ADDENDUM #01

TO CONTRACT DOCUMENTS FOR: PROJECT #CP250051 – Agriculture Engineering Building – Rms 164/166 Fermentation Lab Renovation

PREPARED FOR: The Curators of the University of Missouri

CONSULTANT: Planning, Design & Construction
University of Missouri
130 General Services Building
(573) 882-6800

LEVEL 01 & 02 PLANS - PLUMBING

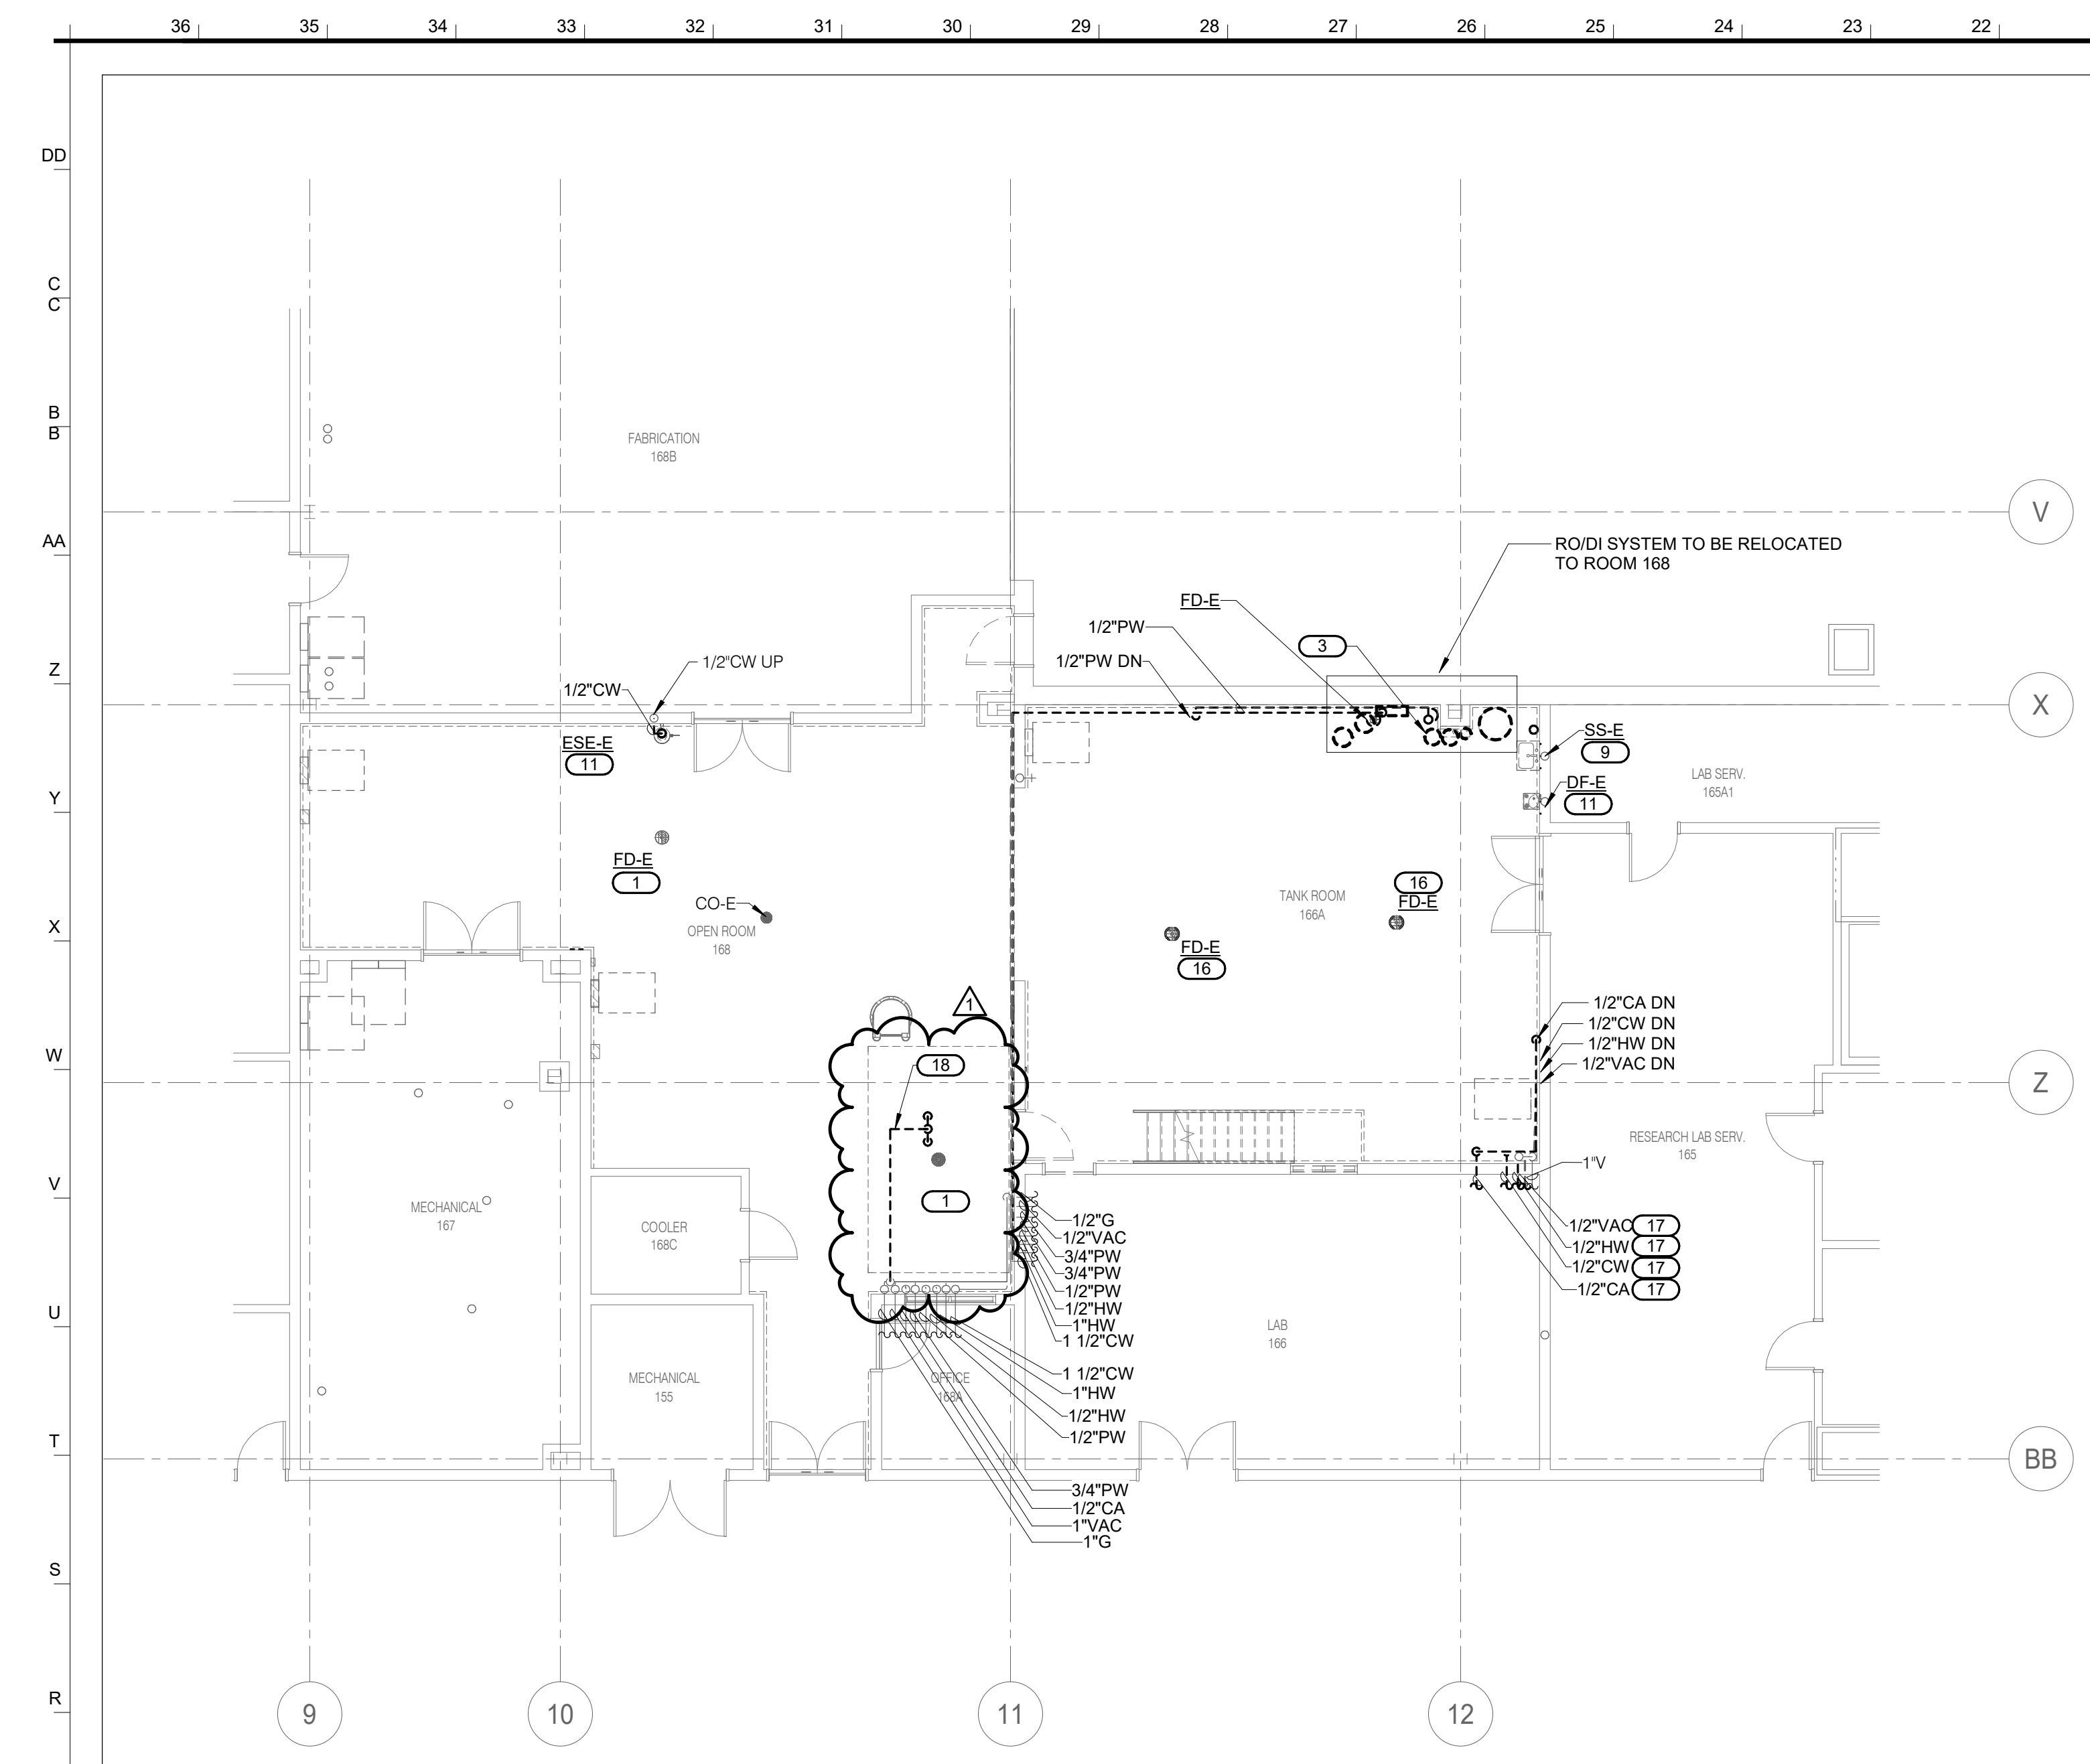
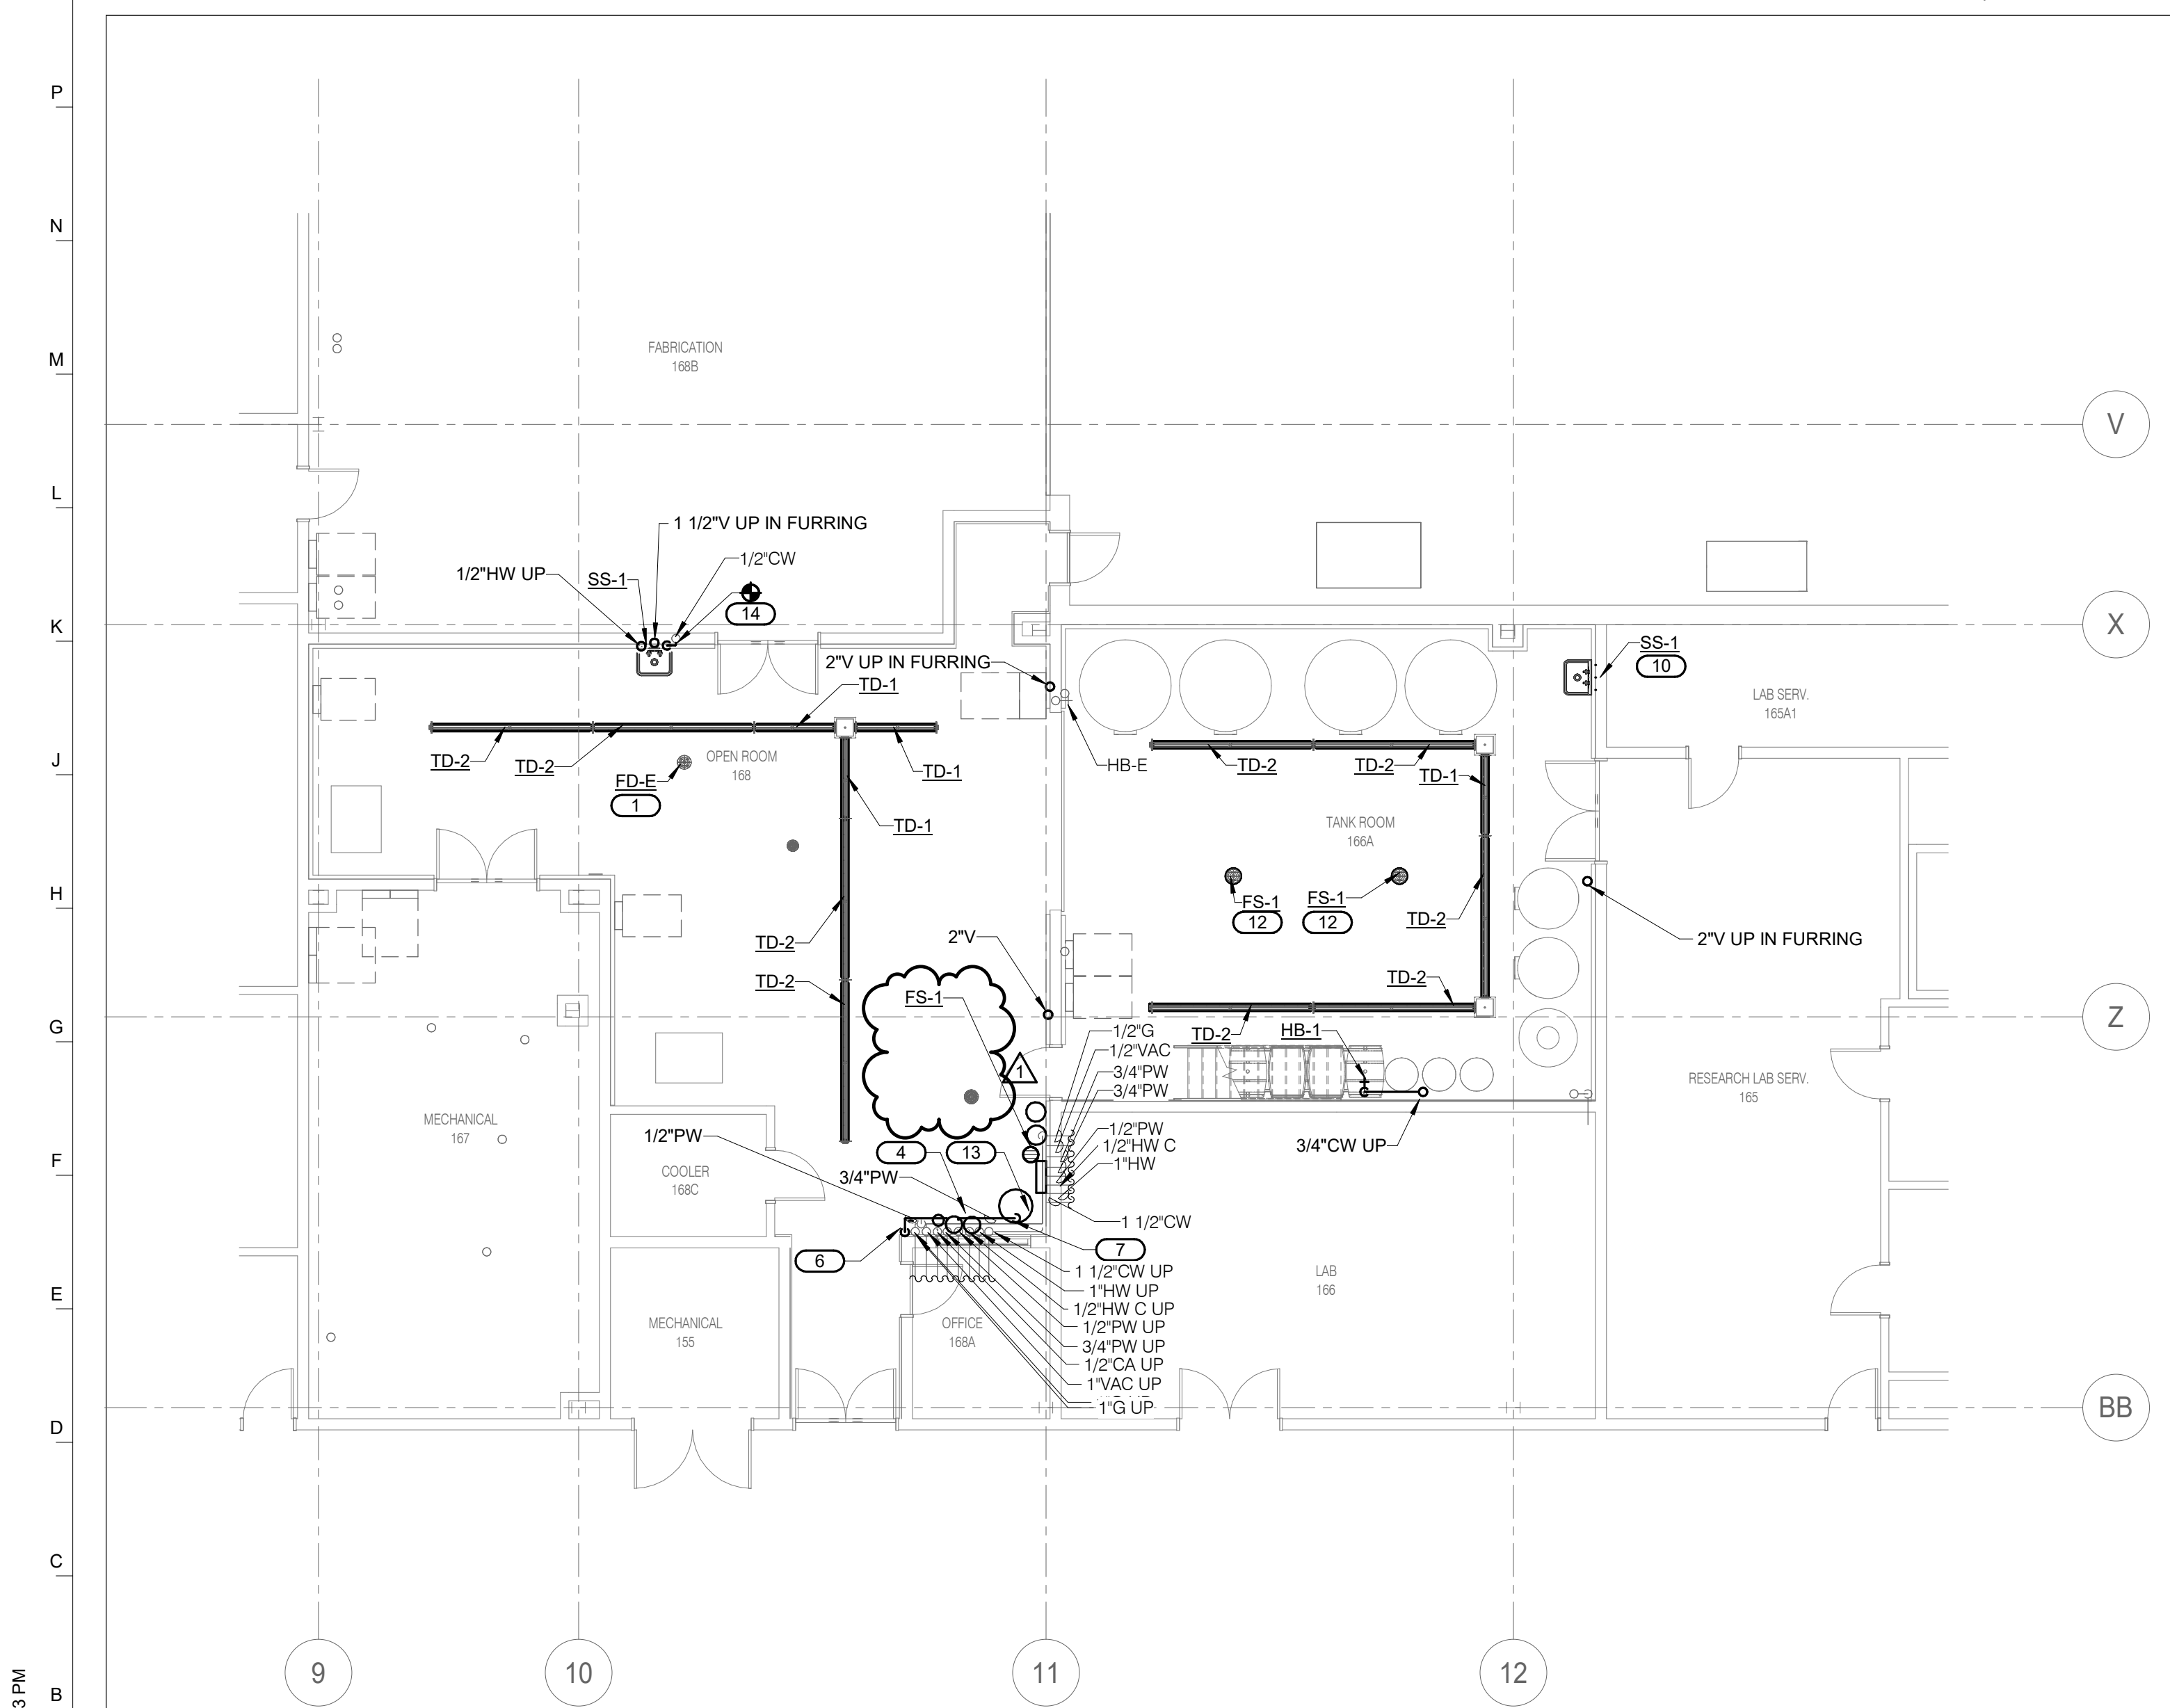
CLARIFICATION: Removed existing floor drain in Room 168.
Demo piping and note added in Room 168.
Revised Keynote 1 with added existing drain information.
New Keynote 18.
Added FS-1 tag in Room 168.

- KEYNOTES:**
- EXISTING JOSAM 3000A FLOOR DRAIN GRATE TO BE REPLACED WITH 3/16 STAINLESS STEEL FULL GRATE WITH 1/2" SQUARE OPENINGS.
 - STEEL STRUCTURE AT APPROX. 27'8" AFT. COORDINATE LOCATION WITH ARCHITECT PRIOR TO INSTALLATION.

- REMOVE FLOOR DRAIN, GRATE, AND PIPING NOT REQUIRED TO REMAIN.
 - REMOVE EXISTING PIPING UP TO THE POINT OF CONNECTION TO MAINS. CAP CONNECTION POINT.
